Technical Service Bulletin: TSB150051

Engine Brake Wiring Harness Design Change

Figure 1, Number 1 on Left: Previous Design. Number 2 on Right: New Design Including Mounting Tab.

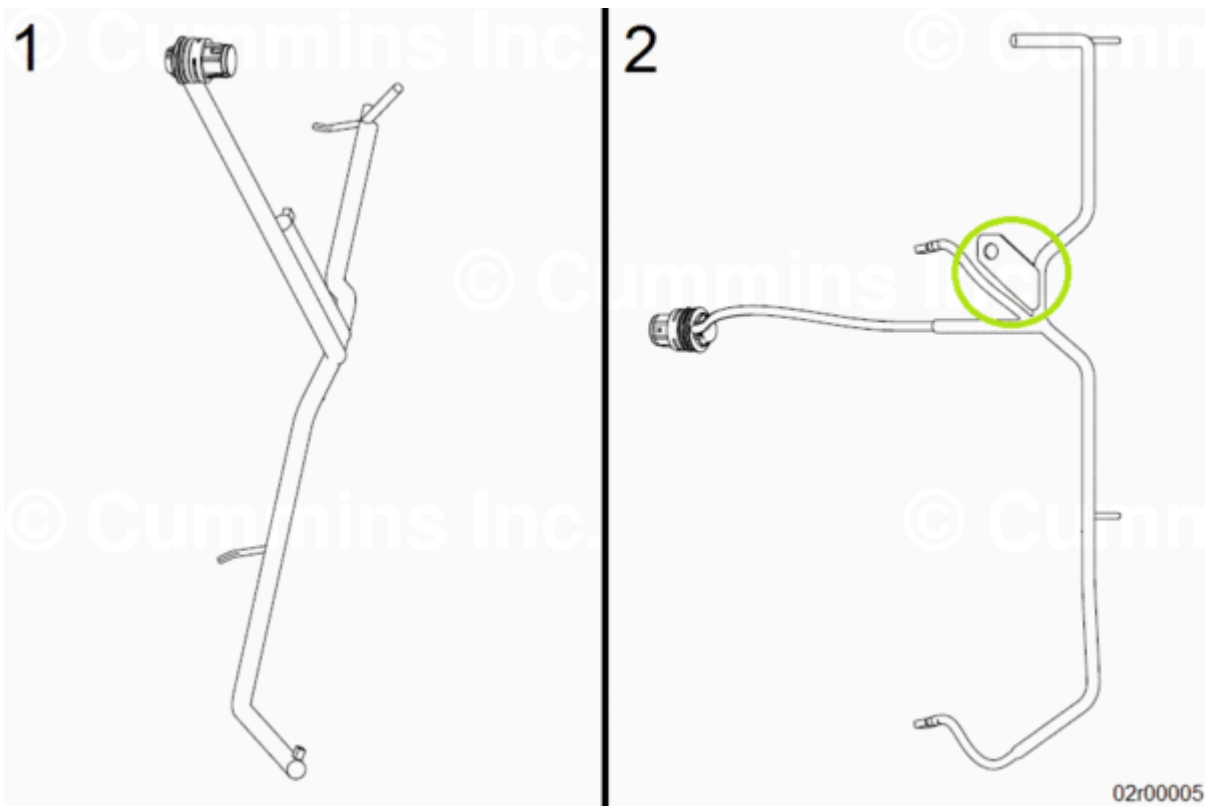
The engine brake wiring harness has been redesigned to include a mounting tab on the harness frame. See Figure 1. The mounting tab secures to a studded capscrew that **must** be used in place of the corresponding rocker shaft mounting capscrew. See Figure 2.

The addition of the mounting tab to the engine brake wiring harness frame improves retention capability and prevents the engine brake wiring harness from making contact with overhead components.
